Re: Reiteration of Hearing Request regarding Application of Galveston County
Landfill TX, LP for Proposed MSW Permit No. 1149B.

Re: Galveston County Landfill, LP Proposed Permit No. 1149B, Municipal Solid Waste Permit Amendment

Re: Comments and Hearing Request regarding Application of Galveston County
Landfill TX, LP for Proposed MSW Permit No. 1149B.

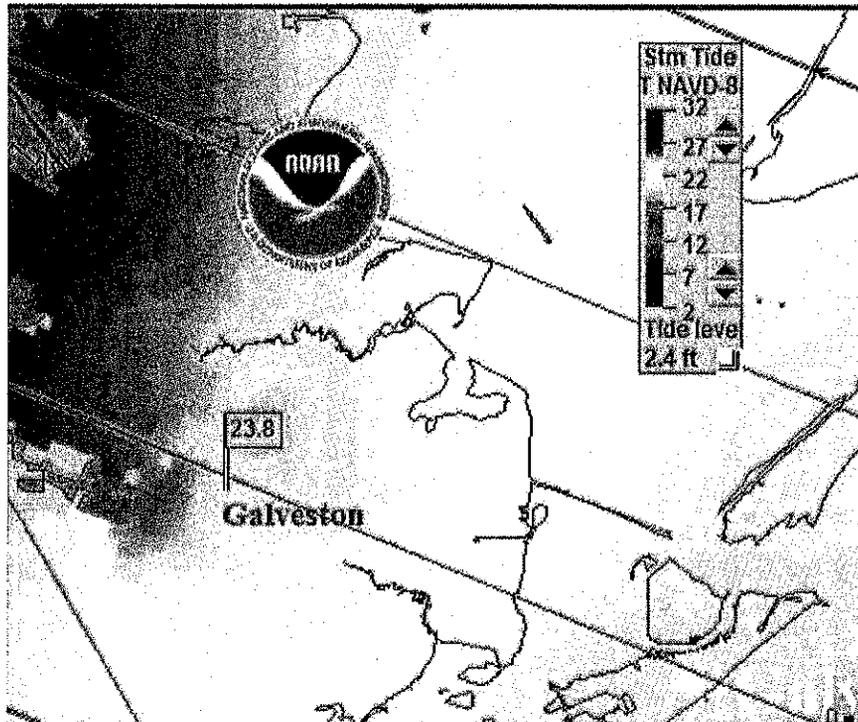
These maps show that much of the landfill site is located within the 100-year floodplain, including areas where Republic now proposed to dispose of municipal solid waste.⁶ In essence, these revised FEMA maps show that at natural elevation the entirety of the site would be located in the 100-year floodplain. Those areas within the permit boundary excluded from the 100-year floodplain apparently reflect elevated surfaces resulting from the construction of the landfill itself.⁷

The occurrence of such flooding is consistent with modeling performed by the National Oceanic and Atmospheric Administration (NOAA). The natural surface of the landfill site ranges from approximately 13 to 16 feet above mean sea level,⁸ and is only a short distance from Galveston Bay. According to NOAA's the Sea, Lake and Overland Surges from Hurricanes (SLOSH) model, a Category 5 hurricane could potentially result in a storm surge at this location to a height of approximately 23 feet above mean sea level:

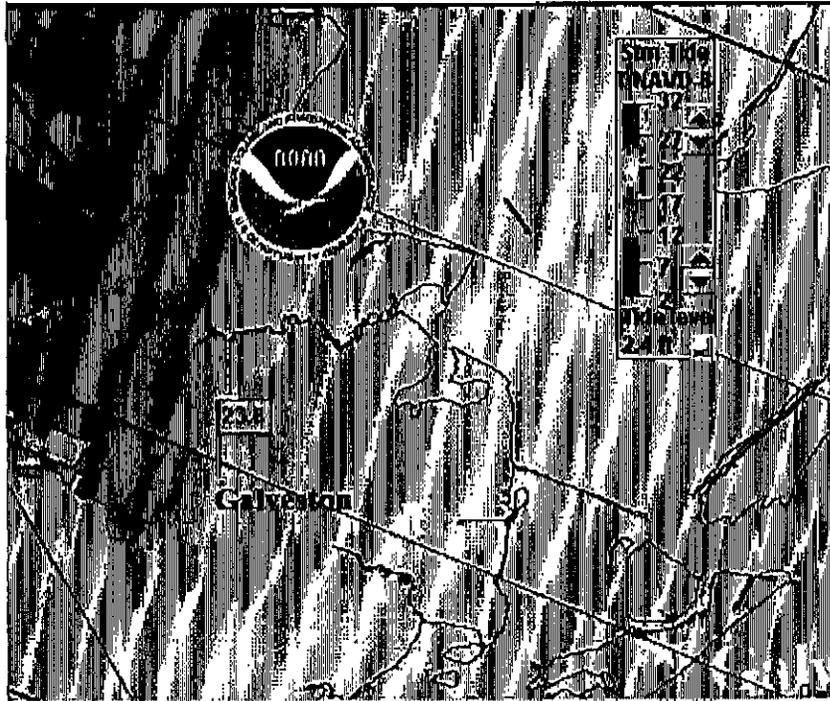
These maps show that much of the landfill site is located within the 100-year floodplain, including areas where Republic now proposed to dispose of municipal solid waste.⁶ In essence, these revised FEMA maps show that at natural elevation the entirety of the site would be located in the 100-year floodplain. Those areas within the permit boundary excluded from the 100-year floodplain apparently reflect elevated surfaces resulting from the construction of the landfill itself.⁷

The occurrence of such flooding is consistent with modeling performed by the National Oceanic and Atmospheric Administration (NOAA). The natural surface of the landfill site ranges from approximately 13 to 16 feet above mean sea level,⁸ and is only a short distance from Galveston Bay. According to NOAA's the Sea, Lake and Overland Surges from Hurricanes (SLOSH) model, a Category 5 hurricane could potentially result in a storm surge at this location to a height of approximately 23 feet above mean sea level:
